23 June 2021

I refer to the Department's below email of 17 June 2021 regarding the public exhibition of the Environmental Impact Statement (EIS) for State Significant Development SSD-10224 New Primary School at Edmondson Park for 'New primary school including 1000 primary school students and a pre-school' at Buchan Avenue, Edmondson Park (Lots 1 and 2 DP 1257105) in the Liverpool City Local Government Area. Submissions need to be made to the Department by 14 July 2021.

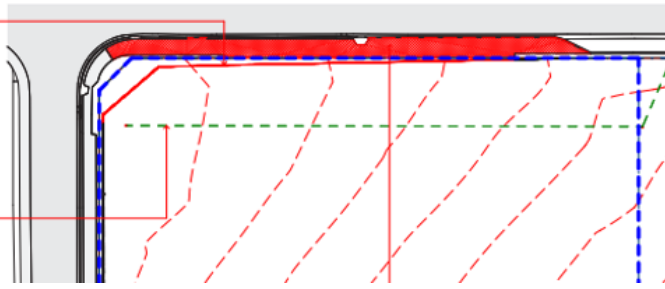
As shown in the below site plans from Endeavour Energy's G/Net master facility model (and extract from Google Maps Street View) there is:

- An easement benefitting Endeavour Energy (indicated by red hatching) for overhead power lines which currently has no 'Inservice' electricity infrastructure.
- Low voltage and 11,000 volt / 11 kilovolt (kV) high voltage underground cables to the Buchan Avenue road verge / roadway.

Please note the location, extent and type of any electricity infrastructure, boundaries etc. shown on the plan is indicative only. In addition it must be recognised that the electricity network is constantly extended, augmented and modified and there is a delay from the completion and commissioning of these works until their capture in the model. Generally (depending on the scale and/or features selected), low voltage (normally not exceeding 1,000 volts) is indicated by blue lines and high voltage (normally exceeding 1,000 volts but for Endeavour Energy's network not exceeding 132,000 volts / 132 kV) by red lines (these lines can appear as solid or dashed and where there are multiple lines / cables only the higher voltage may be shown). This plan only shows the Endeavour Energy network and does not show electricity infrastructure belonging to other authorities or customers owned electrical equipment beyond the customer connection point / point of supply to the property. This plan is not a 'Dial Before You Dig' plan under the provisions of Part 5E 'Protection of underground electricity power lines' of the Electricity Supply Act 1995 (NSW).

### 2.2.2 NEW KIOSK SUBSTATION AND NEW MAIN SWITCHBOARD

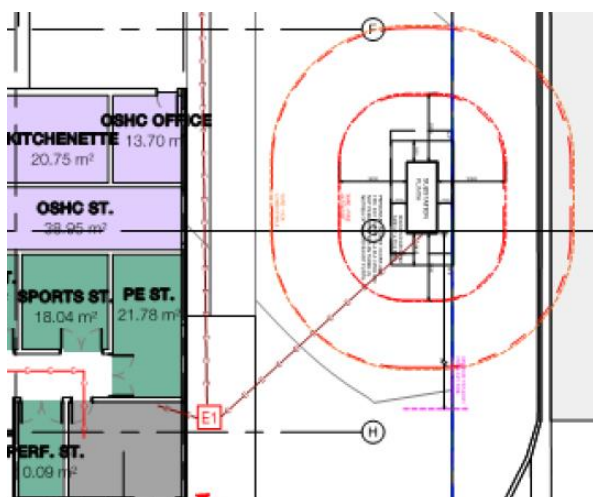
From Endeavour Energy's perspective the fact that provision is being made for a padmount substation is a positive. Endeavour Energy's general requirements is for a padmount substation to be at ground level and have direct access from a public street (unless provided with appropriate easements for the associated underground cables and right of access).

As shown in the following extract of Endeavour Energy's Mains Design Instruction MDI 0044 'Easements and Property Tenure Rights', Figure A4.3 'Padmount easements and clearances', padmount substations require:

- Easement with a minimum size of 2.75 x 5.5 metres (single transformer).
- Restriction for fire rating which usually extends 3 metres horizontally from the base of the substation footing / plinth and 6 metres vertically from the same point.
- Restriction for swimming pools which extends 5 metres from the easement.

#### A4.3 - Padmount easements and clearances

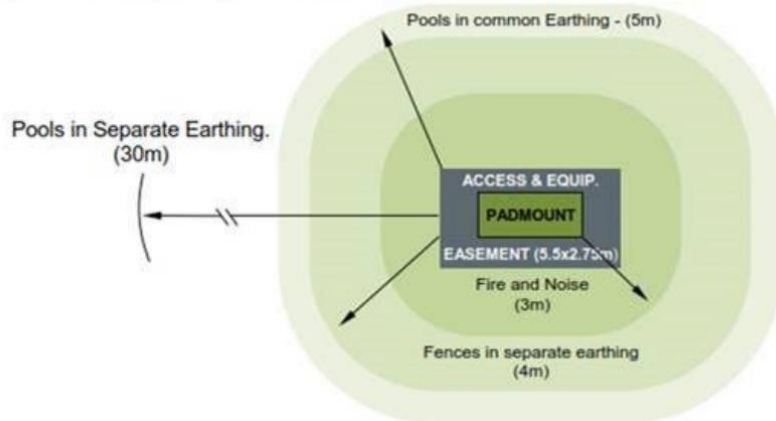
The easement should not cross property boundaries but the restriction/s may affect any adjoining property provided they are able to be registered on the title to that property. In addition the following matters also need to be considered in regard to the fire restriction:

- Personnel access doors and fire exit doors to a building are not permitted within the fire restriction area.
- Gas mains/pipes shall not pass through the fire restriction area.
- A 10 metre clearance distance shall be maintained between substation and fire hydrants, booster valves, and the like in accordance with AS2419.1 'Fire hydrant installations System design, installation and commissioning' as updated from time to time.
- Consideration should be provided to the appropriateness of the landscaping relative to the fire restriction for the substation. Any landscaping that potentially could transfer / provide connectivity for flame or radiant heat from a fire in the substation to a dwelling or building should be avoided.
- The storage of and / or use of flammable, combustible, corrosive or explosive material within the fire restriction should be avoided.

*Figure 21: View of the site at the north-west corner, looking north-east (Source: City Plan)*

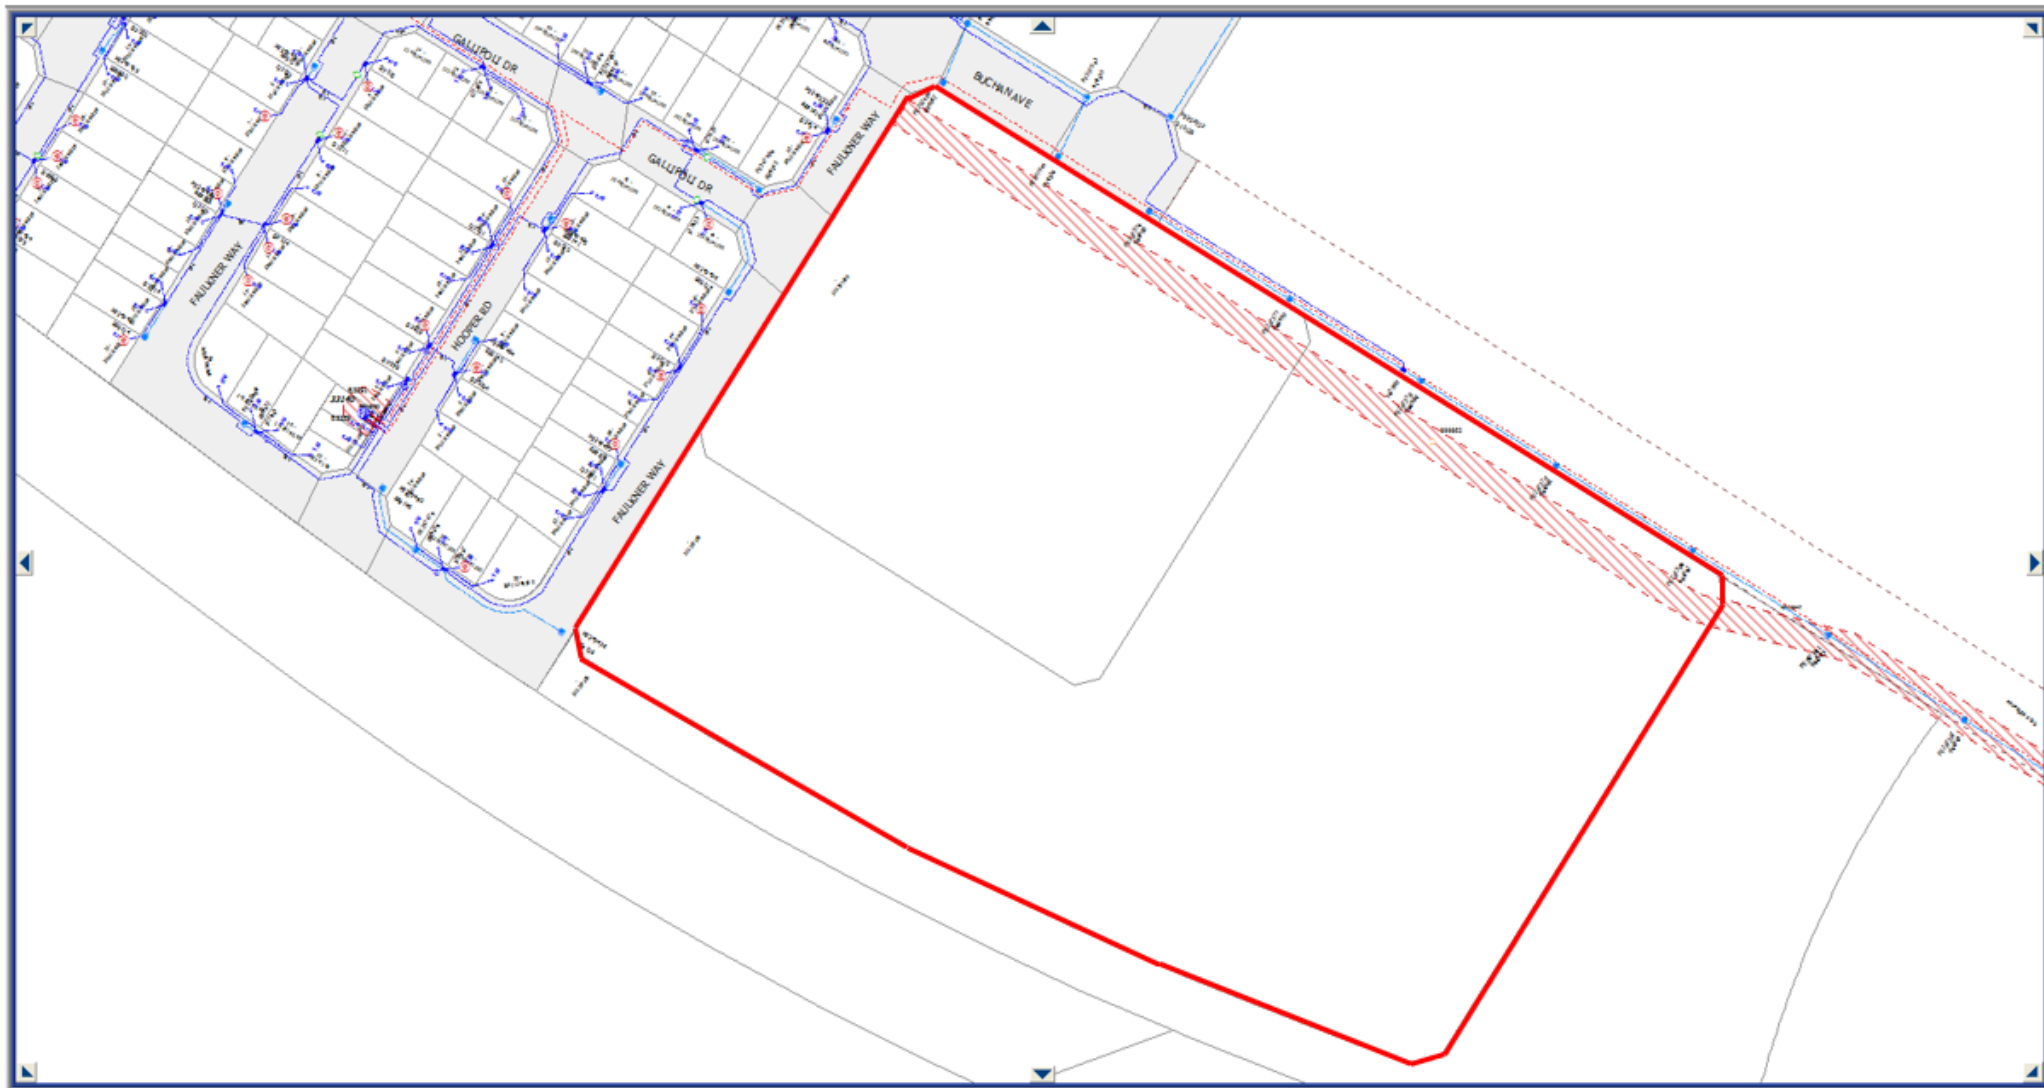
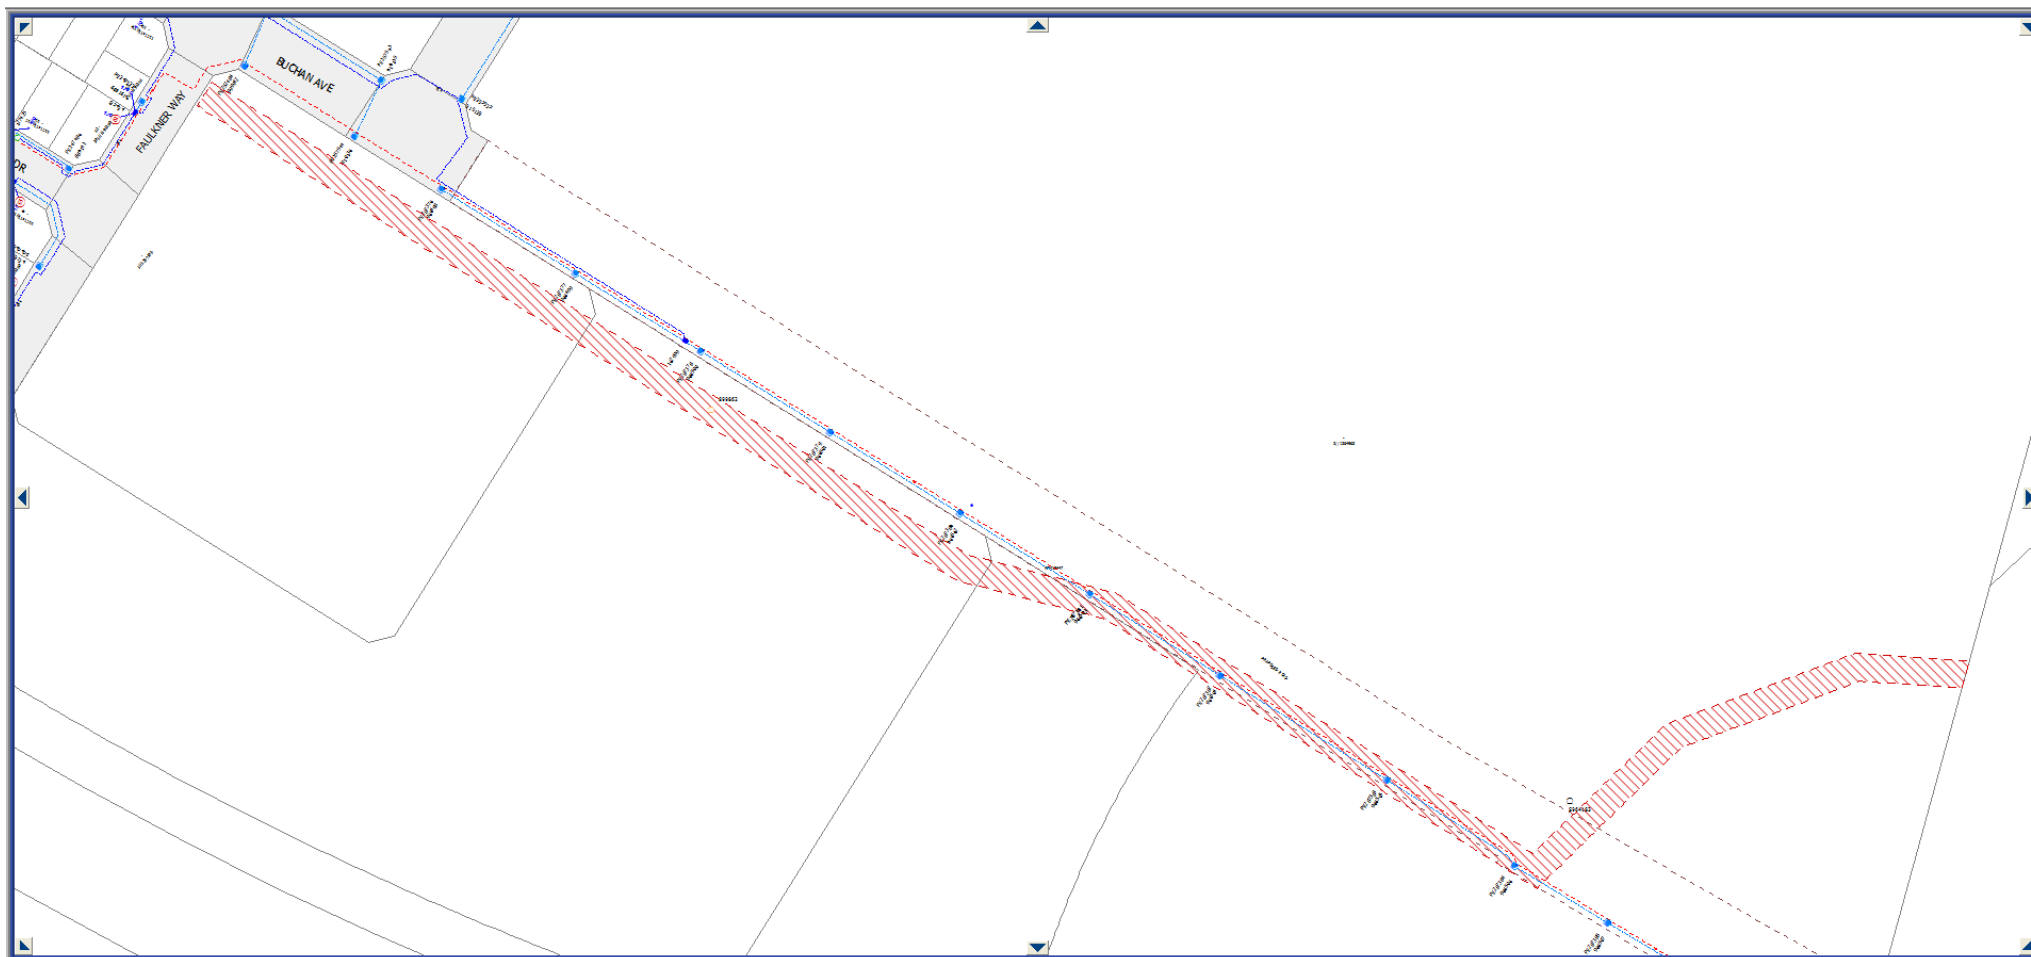
Endeavour Energy has noted that the Environmental Site Assessment dated 21 May 2021 does not appear to identify the electricity infrastructure on or in vicinity of the site which is likely to become redundant assets as a result of the proposed development as potential areas of environmental concern (AEC) and associated contaminants of potential concern (COPC) - although in this instance it appears the overhead power lines and poles within the easement have already been removed although the following extract of the photographs in the EIS taken by City Plan during a site visit on 16 April 2021 still show the overhead power lines traversing the site.

Endeavour Energy's Environmental Business Partner Team have advised that the remediation of soils or surfaces impacted by various forms of electricity infrastructure is not uncommon but is usually not significant eg. transformer oil associated with leaking substations, pole treatment chemicals at the base of timber poles etc. The method of remediation is generally the removal of the electricity infrastructure, removal of any stained surfaces or excavation of any contaminated soils and their disposal at a licensed land fill. The decommissioning and removal of the redundant electricity infrastructure will be dealt with by Endeavour Energy's Network Connections Branch as part of the application for the connection of load for the new development – please refer to the above point 'Network Capacity / Connection'.

The overhead power lines within the easement have been removed and arrangements for the release of easement are in place.
